CITY OF NAPERVILLE

<u>HISTORIC PRESERVATION COMMISSION CERTIFICATE OF APPROPRIATENESS</u> (COA) APPLICATION - REQUEST FOR DEMOLITION

Property Address and PIN number(s) of structure(s) sought to be demolished ("Subject Property"):	127 S Columbia St Naperville, IL 60540 Sunroom demolition and rebuild
Applicant's Name:	Matt McNichols
Applicant's Address/Zip:	127 S Columbia Street
Applicant's Telephone # Day/Evening:	630-596-7662
Applicant's Fax (optional):	
Applicant's Email:	mcnich10@gmail.com
Property Owner's Name(s), if other than the Applicant:	
Property Owner's Address/Zip:	
Property Owner's Telephone # Day/Evening

HISTORIC PRESERVATION COMMISSION CERTIFICATE OF APPROPRIATENESS (COA) APPLICATION PACKET

127 S. COLUMBIA STREET CHICAGO AVENUE ELEVATION THOMAS J. RYAN, JR. - ARCHITECT

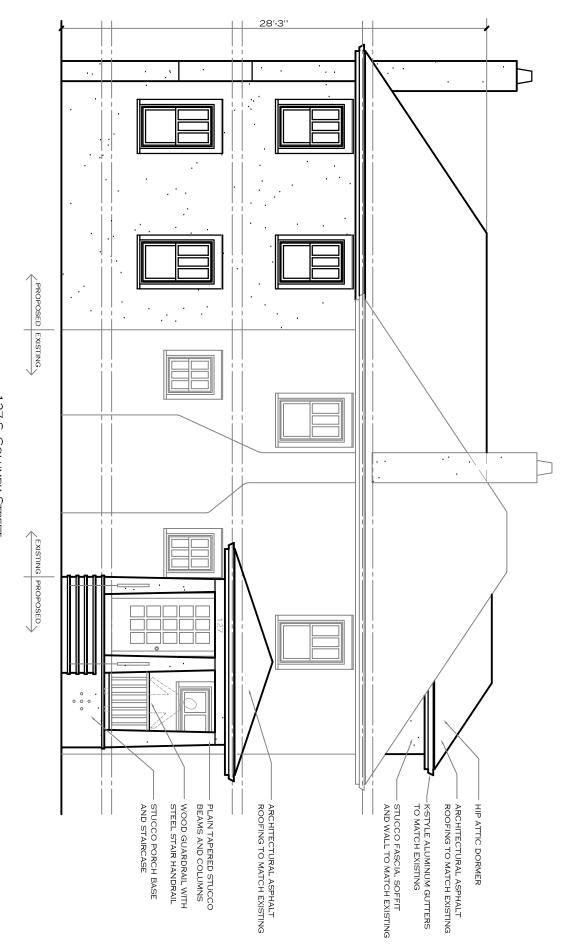
Please further explain and expound on why there will not be an effect on any of the external architectural features as described in your response for question C on page 3 of the COA application – request for demolition packet (attached). The demolition of the sunroom and additions would change the overall appearance of the façade, so those changes should be added to this section.

While the addition will not impact any of the existing home features, the façade will change to include the addition since it is viewable from the front (main) entrance. It will not degrade any architectural features of the original, since it will mimic the same characteristics of the original home. The difference to most people will be that the structure is 2 stories. The scale is not drastically different, since it was designed to appear smaller than the main home. So to the public it will appear larger mainly in its height.
